# UNITED STATES PATENT AND TRADEMARK OFFICE

APPLICATION NO.	FILING DATE	FIRST NAMED INVENTOR	ATTORNEY DOCKET NO.	CONFIRMATION NO.
10/727,306	12/03/2003	Douglas B. Wilson	114089.120	5202
23483	7590	03/30/2006	EXAMINER	
WILMER CUTLER PICKERING HALE AND DORR LLP 60 STATE STREET BOSTON, MA 02109			LUONG, VINH	
			ART UNIT	PAPER NUMBER
			3682	
DATE MAILED: 03/30/2006

**Office Action Summary**

## **ATTACHMENT # 1**

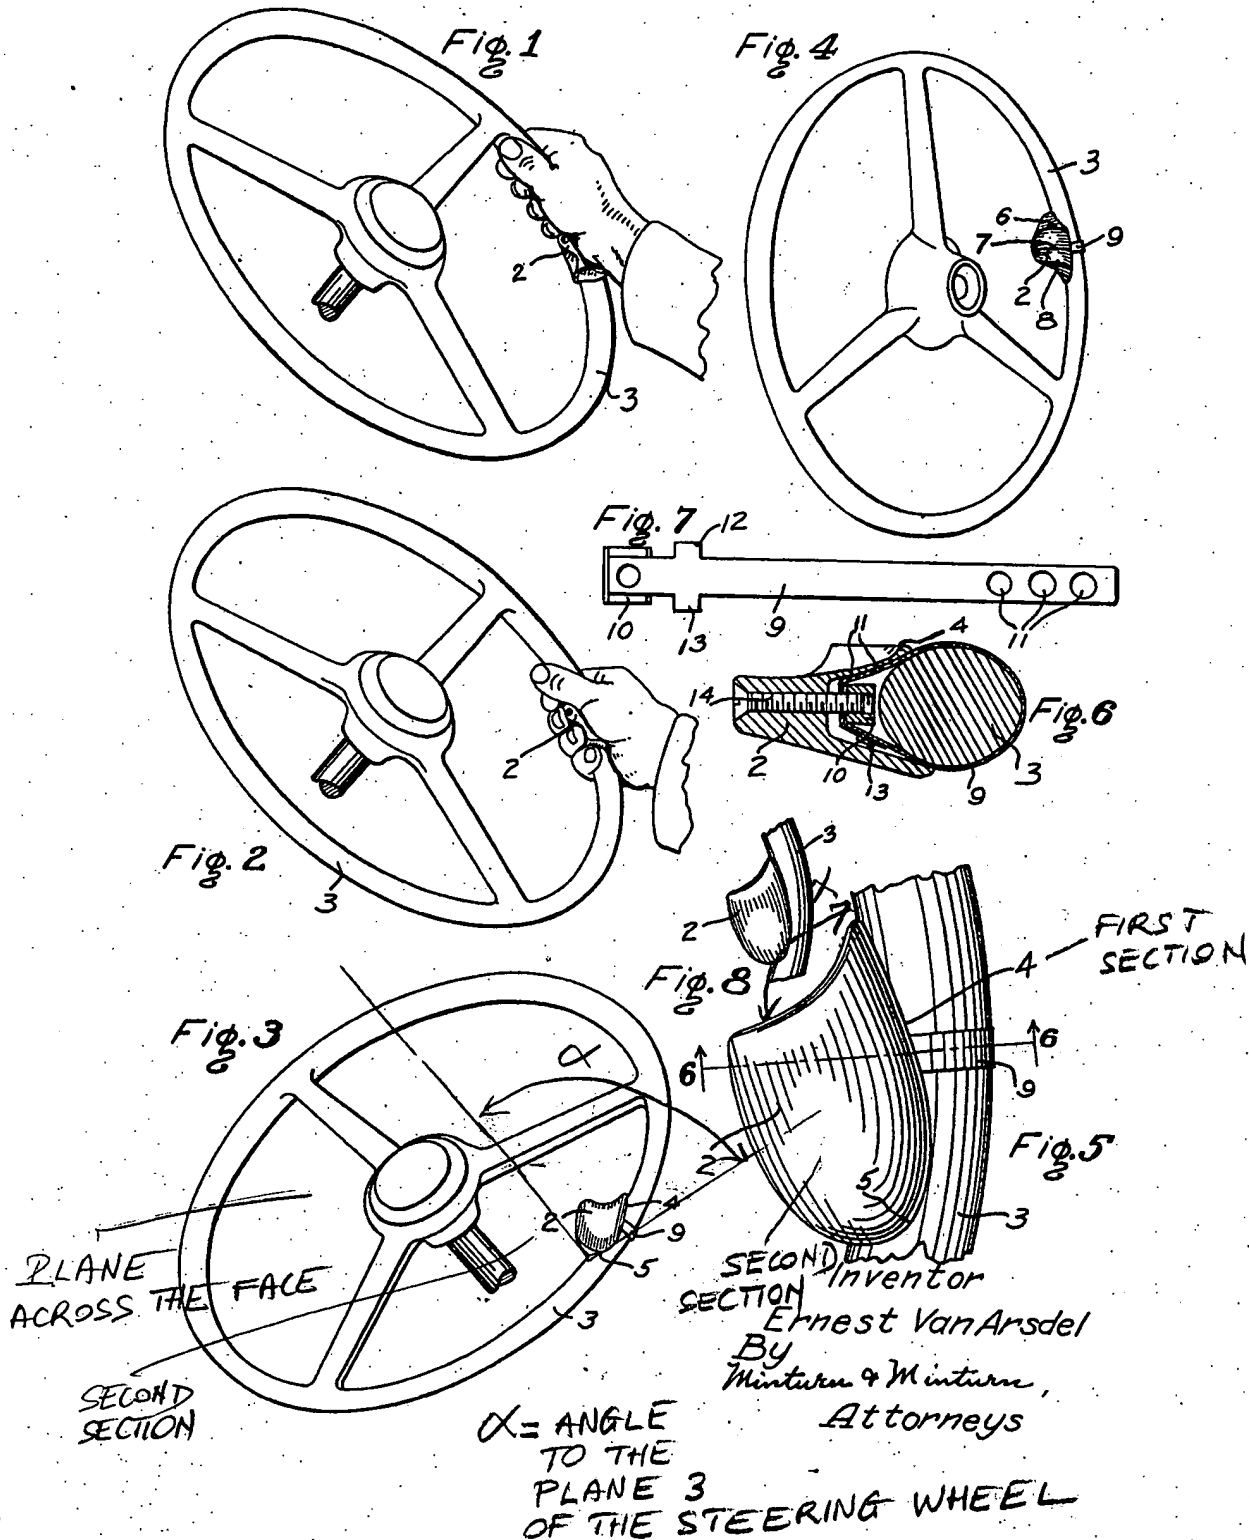
Regarding claim 14, Van Arsdell teaches a fatigue relieving/preventing apparatus associated with a steering wheel 3 for controlling a vehicle, comprising:

a first section 4 (i.e., a horizontal section) that connects to a peripheral portion of the steering wheel 3; and

a rigid, semi-rigid or flexible, or non-deformable second section 2 that connects to, and extends from the first section 4 at the peripheral portion of the steering wheel 3, the second section 2 extends from the first section 4 outward at an angle (see angle  $\alpha$  in Figs. 3 and 5 of Attachment 1) to a plane (Att. 1) across a front face of the steering wheel 3, the second section 2 for supporting at least a portion of a vehicular operator's body when pressure from the portion of the vehicular operator's body on the second section 2 is less than the pressure for deforming the second section 2 out of interference with the vehicular operator's ability to operate the steering wheel 3, and deforming out of interference with the vehicular operator's ability to operate the steering wheel 3 when pressure from the portion of the vehicular operator's body on

the second section 2 is equal to or greater than the pressure for deforming the second section 2 out of interference with the vehicular operator's ability to operate the steering wheel 3.

Regarding claim 17, the first section 4 extends a length of a predetermined peripheral portion of the steering wheel 3.

Regarding claim 24/14, each first section 4 is formed integral with the steering wheel 3. It is well settled that the term "integral" is not restricted to a one-piece article. The term "integral" is sufficiently broad to embrace constructions united by such means as fastening and welding. See *In re Hotte*, 177 USPQ 326 (CCPA); *In re Clark*, 102 USPQ 241 (CCPA); *In re Dike*, 157 USPQ 581 (CCPA); *In re Kohno*, 157 USPQ 275 (CCPA); and *In re Morris*, 43 USPQ2d 1753, 1757 (CAFC 1997).

## **ATTACHMENT # 2**

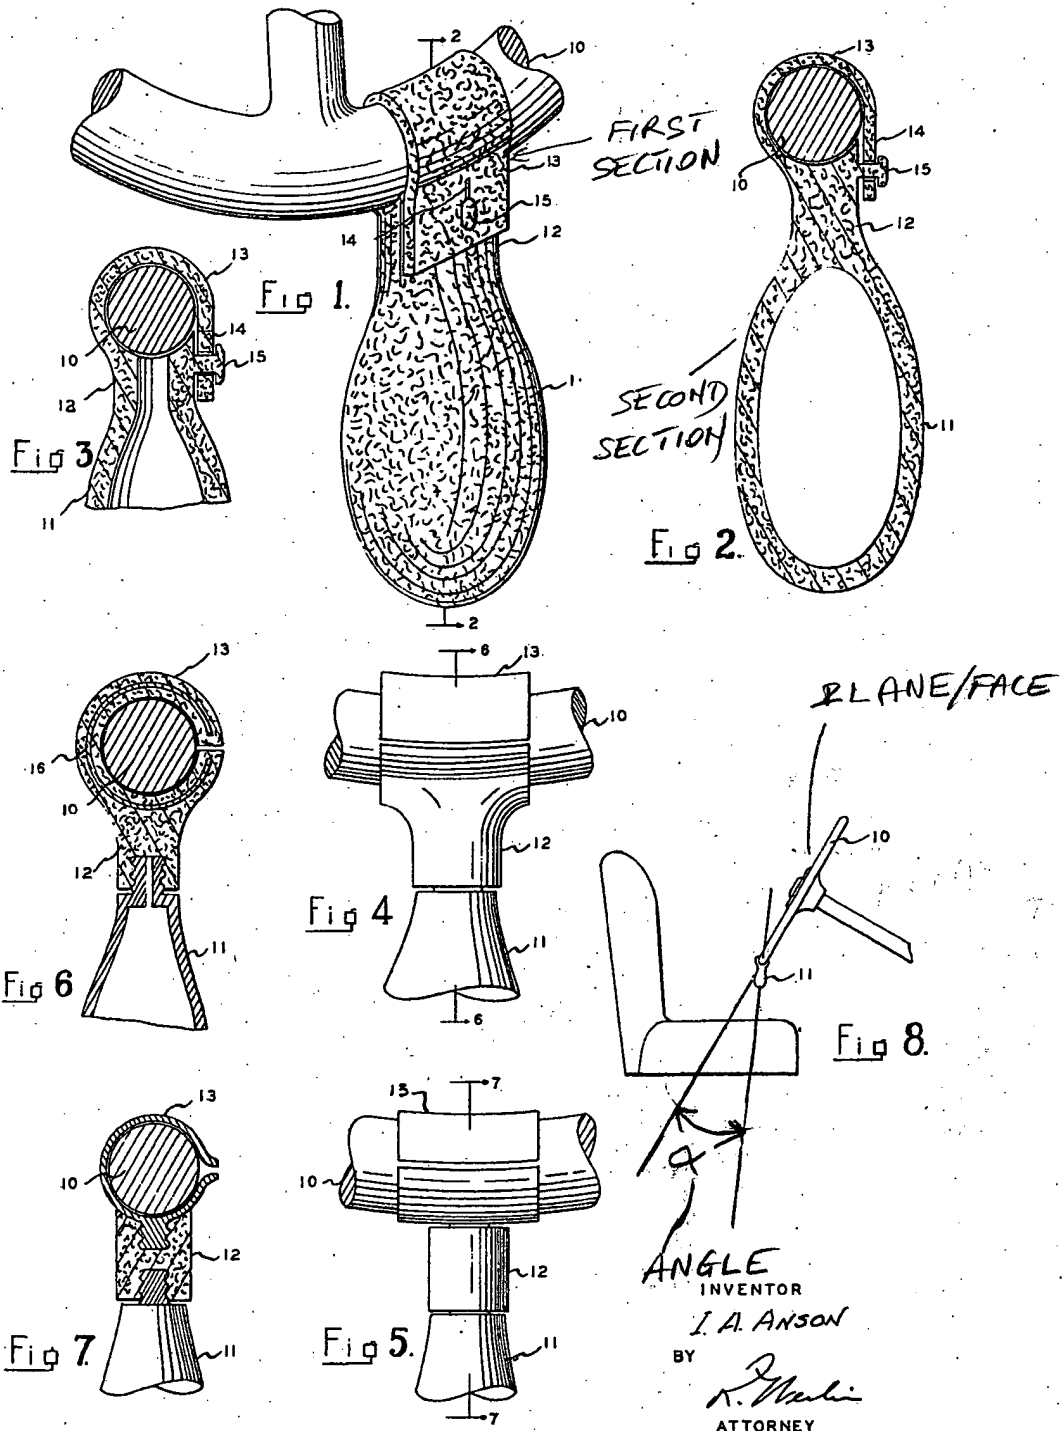
Regarding claim 14, Anson teaches a fatigue relieving/preventing apparatus associated with a steering wheel 10 for controlling a vehicle, comprising:

a first section 13 that connects to a peripheral portion of the steering wheel 10; and  
a rigid, semi-rigid or flexible, or non-deformable second section 11 that connects to, and extends from the first section 13 at the peripheral portion of the steering wheel 10, the second section 11 extends from the first section 13 outward at an angle (see angle  $\alpha$  in Fig. 8 of Attachment 2) to a plane (Att. 2) across a front face of the steering wheel 10, the second section 11 for supporting at least a portion of a vehicular operator's body when pressure from the portion of the vehicular operator's body on the second section 11 is less than the pressure for deforming the second section 11 out of interference with the vehicular operator's ability to operate the steering wheel 10, and deforming out of interference with the vehicular operator's ability to operate the steering wheel 10 when pressure from the portion of the vehicular operator's body on the second section 11 is equal to or greater than the pressure for deforming the second section 11 out of interference with the vehicular operator's ability to operate the steering wheel 10.

Regarding claim 17, the first section 13 extends a length of a predetermined peripheral portion of the steering wheel 10.

Regarding claim 24/14, each first section 13 is formed integral with the steering wheel 10. See *In re Hotte*; *In re Clark*; *In re Dike*; *In re Kohno*; and *In re Morris, supra*.

## **ATTACHMENT # 3**

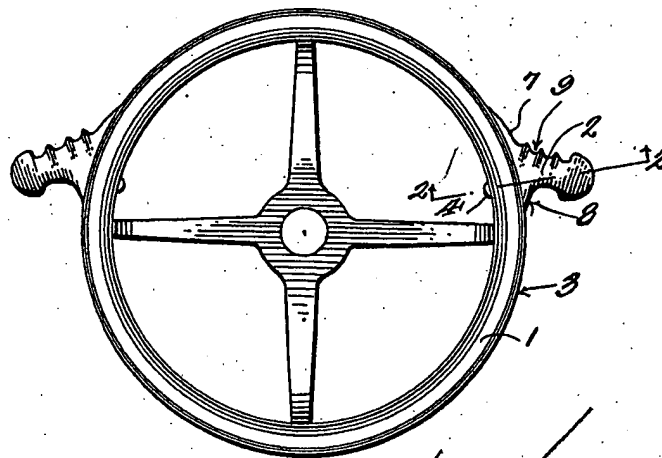
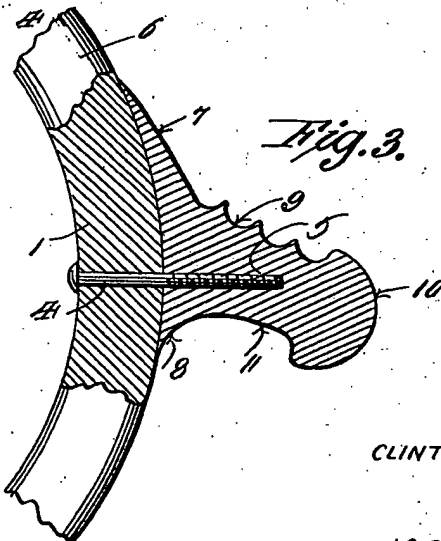
Regarding claim 14, Laubach teaches a fatigue relieving/preventing apparatus associated with a steering wheel 1 for controlling a vehicle, comprising:

a first section 7, 8 that connects to a peripheral portion of the steering wheel 1; and  
a rigid, semi-rigid or flexible, or non-deformable second section 10 that connects to, and extends from the first section 7, 8 at the peripheral portion of the steering wheel 1, the second section 10 extends from the first section 7, 8 outward at an angle (see angle  $\alpha$  in Fig. 2 of Attachment 3) to a plane (Att. 3) across a front face (Att. 3) of the steering wheel 1, the second section 10 for supporting at least a portion of a vehicular operator's body when pressure from the portion of the vehicular operator's body on the second section 10 is less than the pressure for deforming the second section 10 out of interference with the vehicular operator's ability to operate the steering wheel 1, and deforming out of interference with the vehicular operator's ability to operate the steering wheel 1 when pressure from the portion of the vehicular operator's

body on the second section 10 is equal to or greater than the pressure for deforming the second section 10 out of interference with the vehicular operator's ability to operate the steering wheel 1.

Regarding claim 18, the second section 10 includes at least two second sections (Fig. 1) that each connect to the first section 7, 8 at separate locations.
